**WOODFORD COUNTY BOARD OF EDUCATION
AGENDA ITEM**

TOPIC/TITLE: Phase 2 WCHS Change Order

WCHS Track and Field: Change Order #04 Summary

DATE:	10/17/2024	PR #:	PR 006
TO:	Clay Ratliff – Trace Creek Construction	RE:	Woodford County Board of Education Versailles, Kentucky BG 19-353 RTA 1916 Phase 2

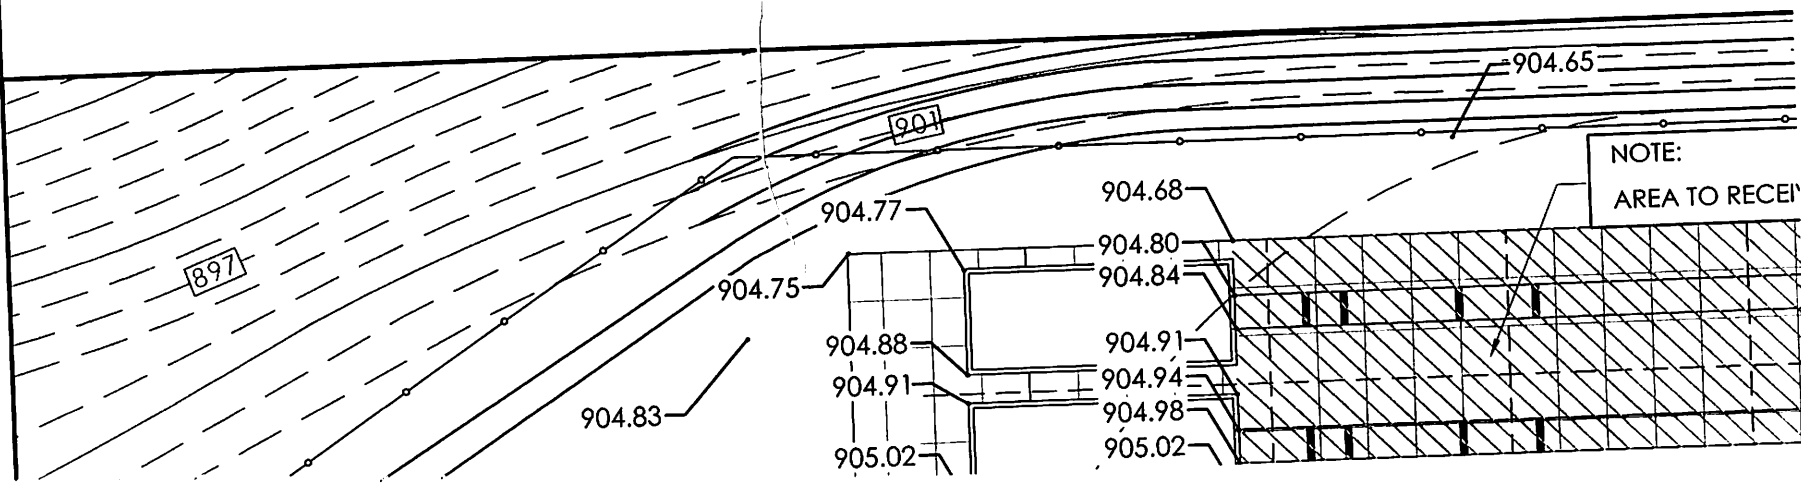
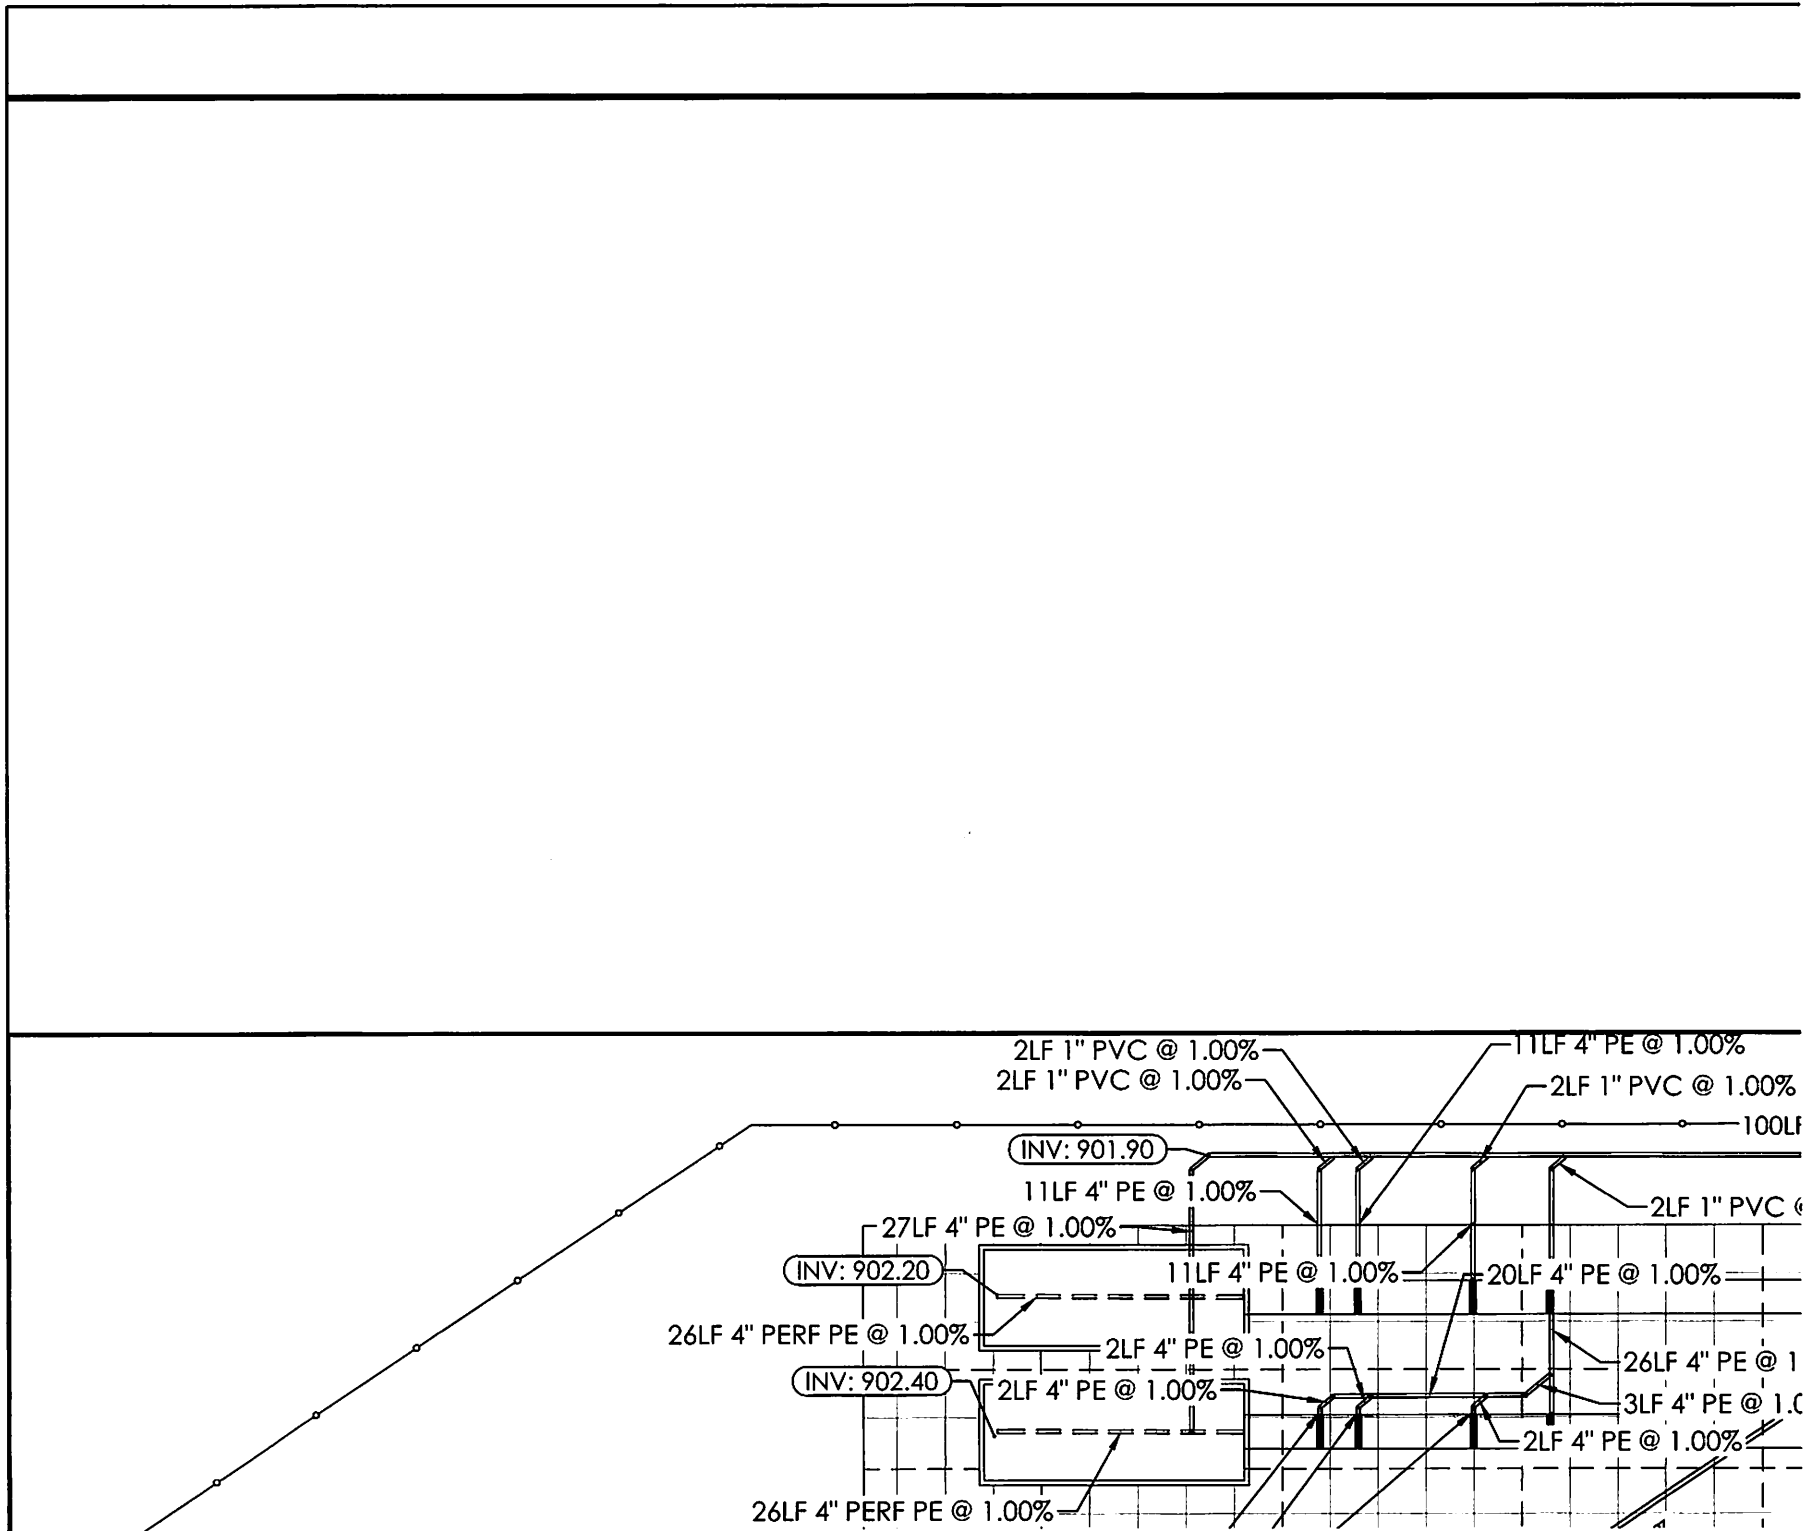
1. Refer to SA1.2 – SITE LAYOUT AND DEVELOPMENT PLAN:
 - a) Add 4" and 6" concrete pavement as shown for bleachers.
 - b) Add bleacher structure.
 - c) Add gravel pavement under bleachers as shown.

- d) Sod area around bleachers as shown.
 - e) Relocate light poles to be 122' O.C. from the 50-yard line.
2. Refer to SA2.1 – SITE GRADING AND DRAINAGE PLAN:

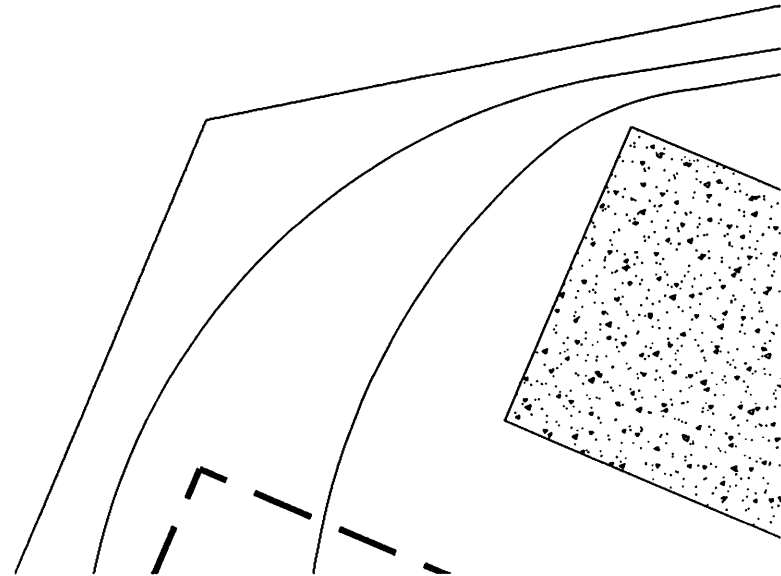
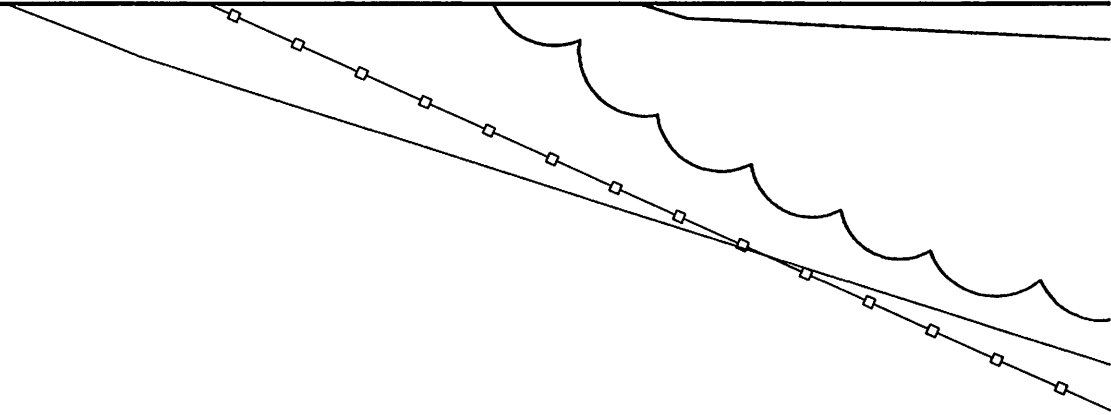
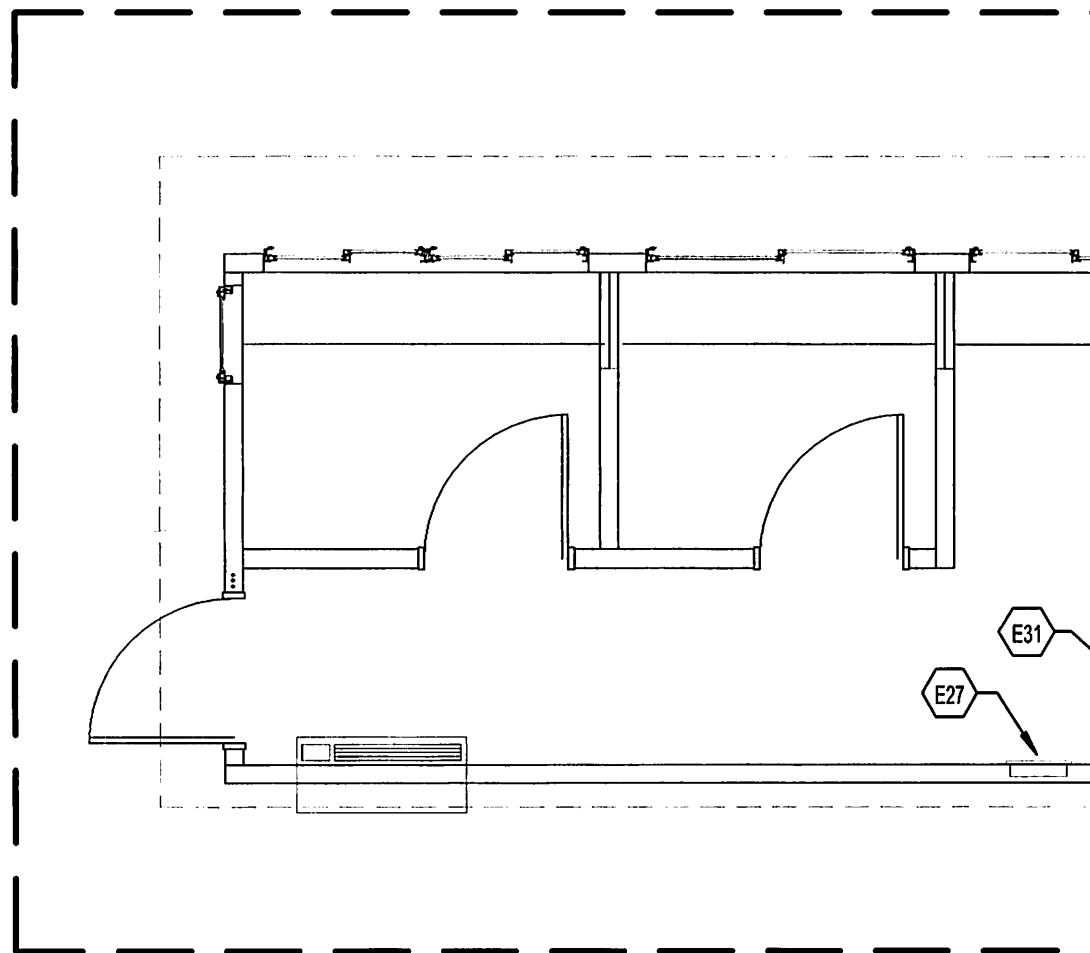
- a) Modify grading and drainage layout as shown.
3. Refer to SA2.2 – SITE GRADING PLAN:
 - a) Slope new pavement at a 1% from north to south.
 - b) Slope area under bleachers at 2% to low point.

- c) Modify swales to not be under bleachers.
 - d) Raise rim/ground elevation over DS-34.
4. Refer to SA2.3 – SITE DRAINAGE PLAN:
 - a) Add perforated piping under bleachers as shown. Space perf pipes 20' minimum O.C. Space around bleacher foundations.

- b) Relocate manhole DS-34 along the outgoing pipe. Adjust piping length and add risers to manhole to meet new grade/rim elevation.
 - c) Tie perforated piping to DS-34 and DS-85. Seal penetrations to be watertight.

1 LIGHTING/POWER PRESSBOX PLAN

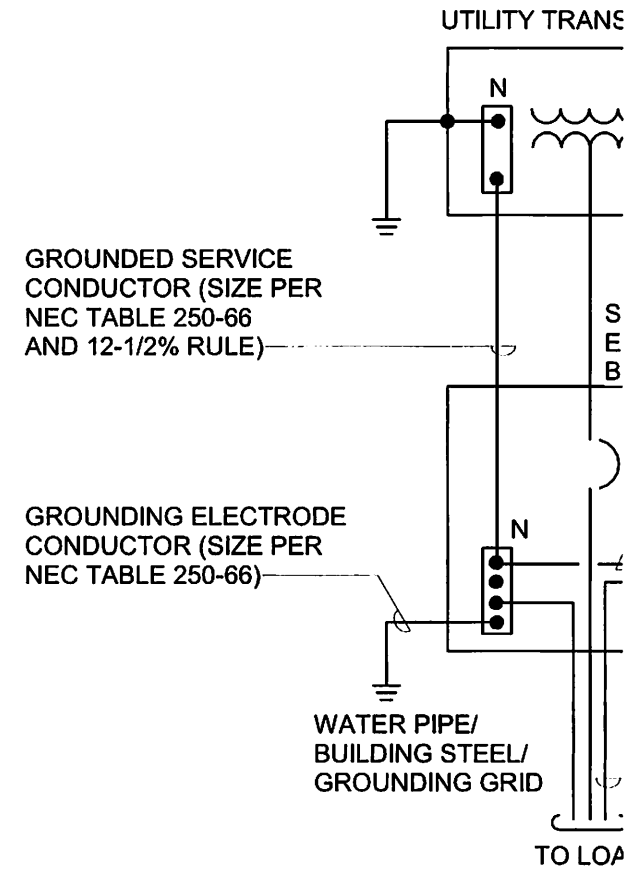
7. Add devices and equipment per E1.2 pressbox plans.
8. Add electrical equipment to support pressbox and videoboard per E2.0 one-line diagram.
9. Add pressbox communication riser and modify fiber one-line diagram to support pressbox and videoboard.
10. Provide a separate price to perform the following work: Upgrade athletic field lighting system to be 50FC.
